**STATE OF TENNESSEE  
DEPARTMENT OF TRANSPORTATION  
DESIGN DIVISION**

**INSTRUCTIONAL BULLETIN NO. 13-08**

**Regarding New and Revised Standard Drawings**

**Effective for the July 12<sup>th</sup> letting (May 1<sup>st</sup> turn-in),** the following Standard Drawings are new or revised and Section V of the Design Guidelines is revised for this update.

SIGNING AND PAVEMENT MARKINGS FOR BICYCLE ROUTES ON RURAL ROADS

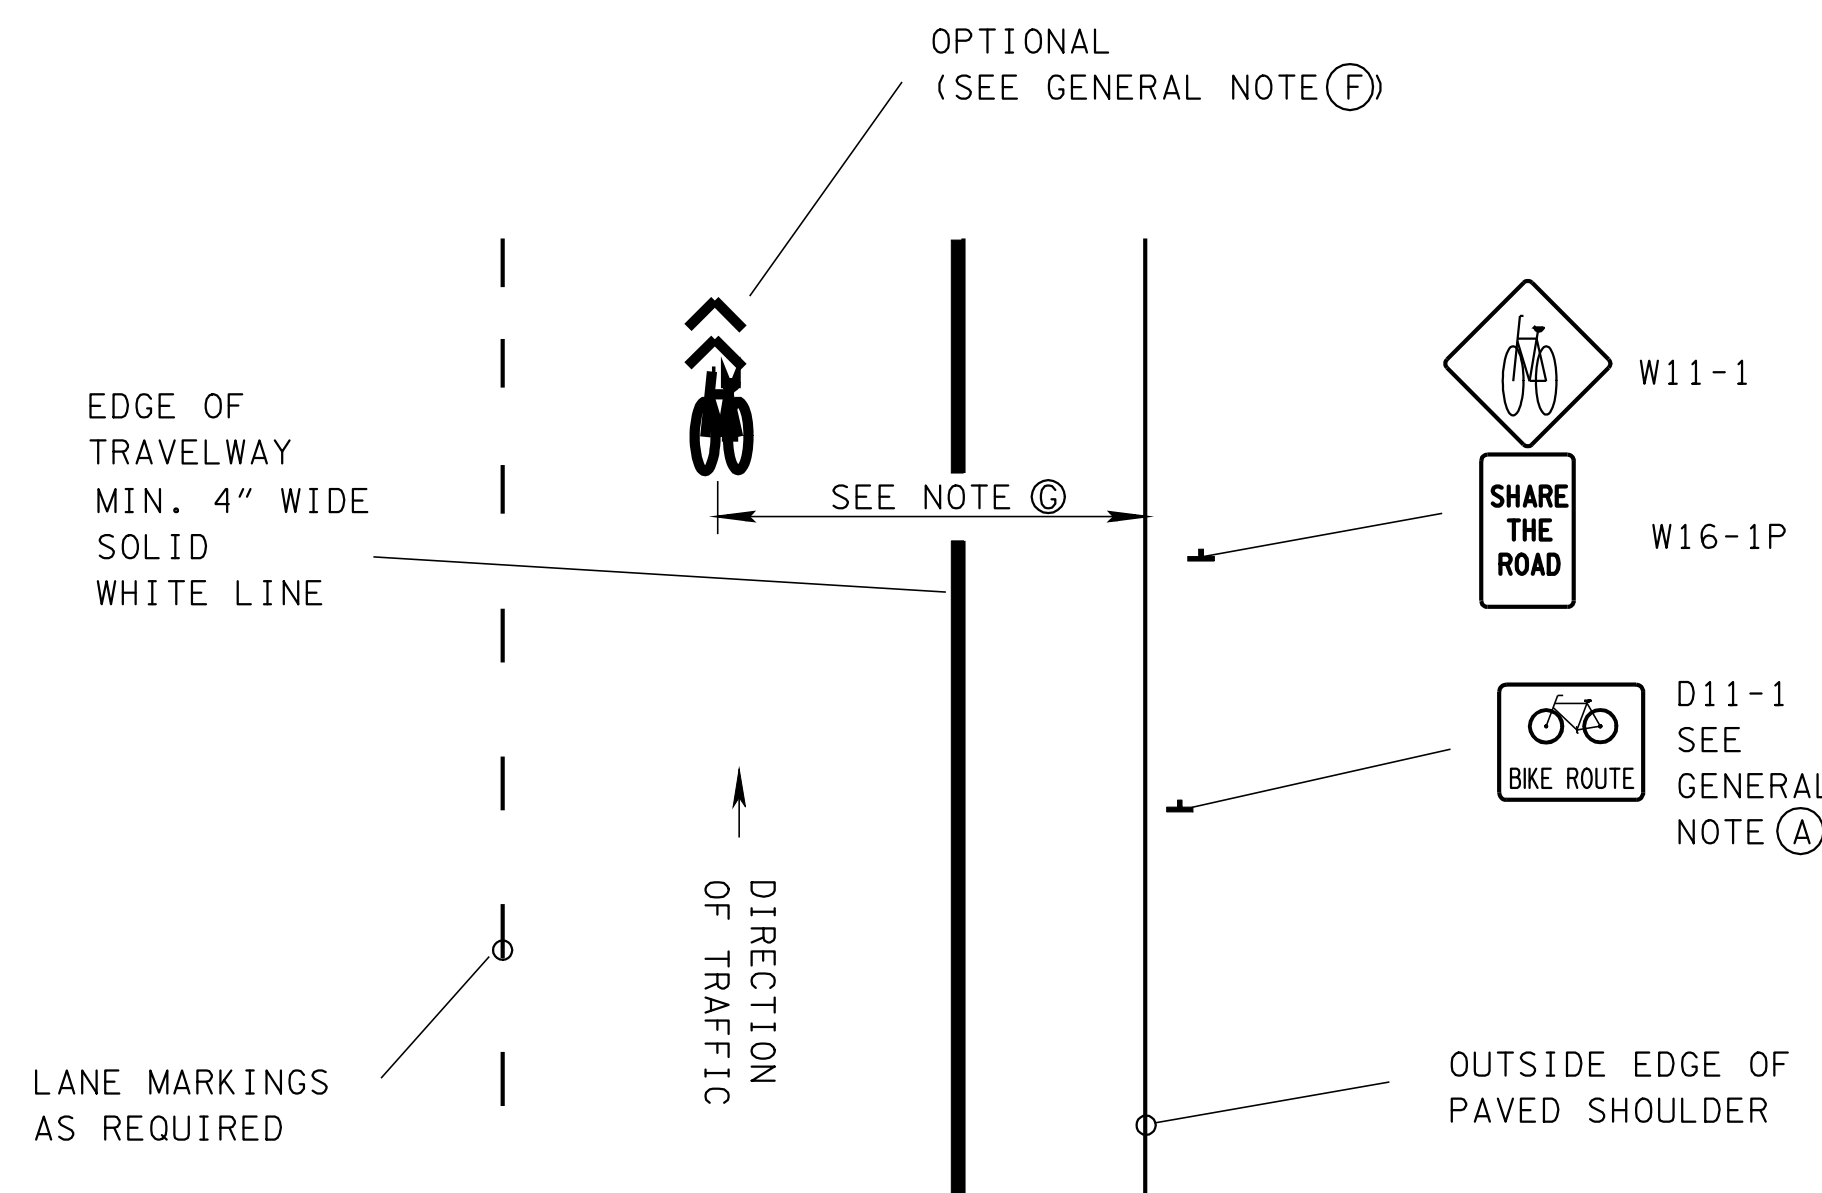
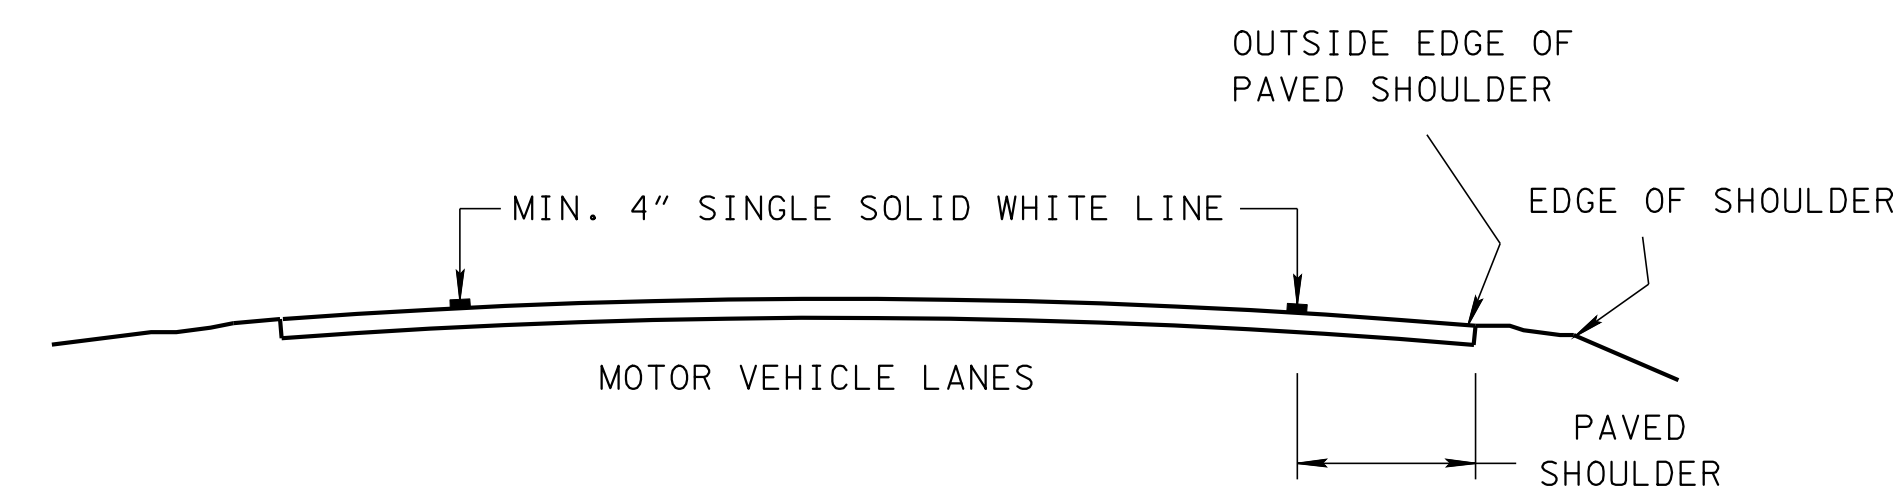
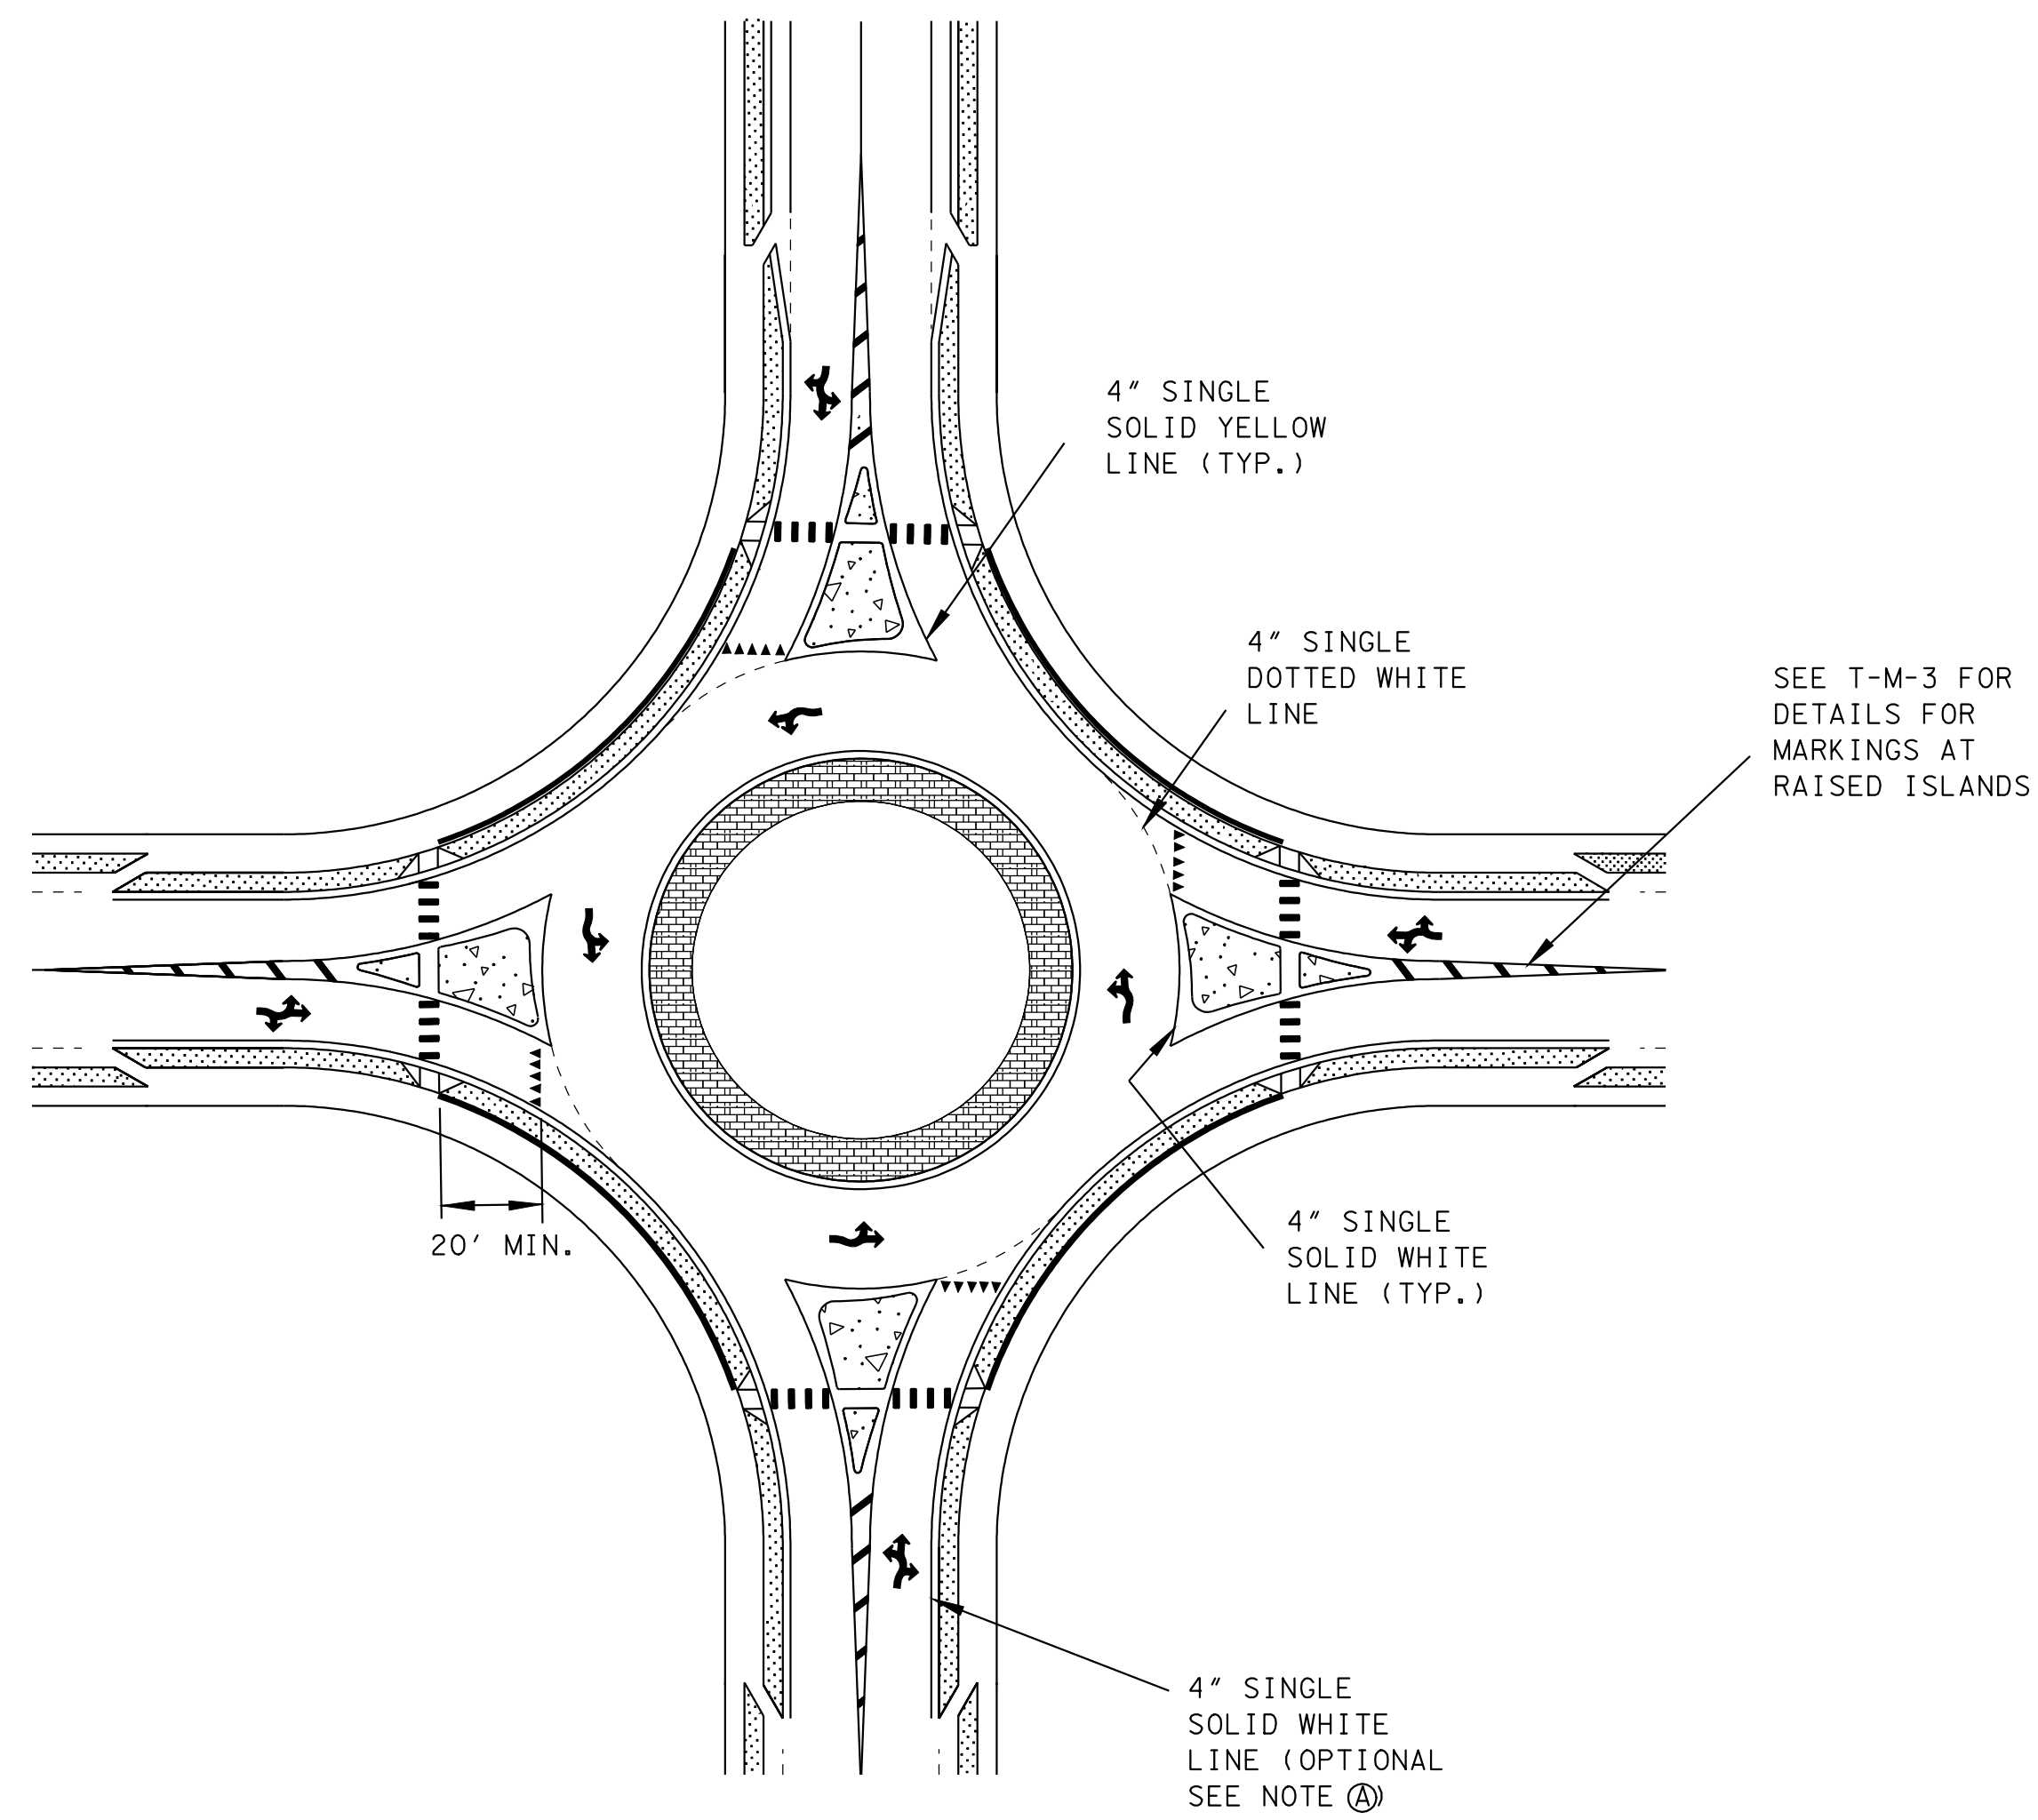
REV. 6-15-12: ADDED NOTE (C).
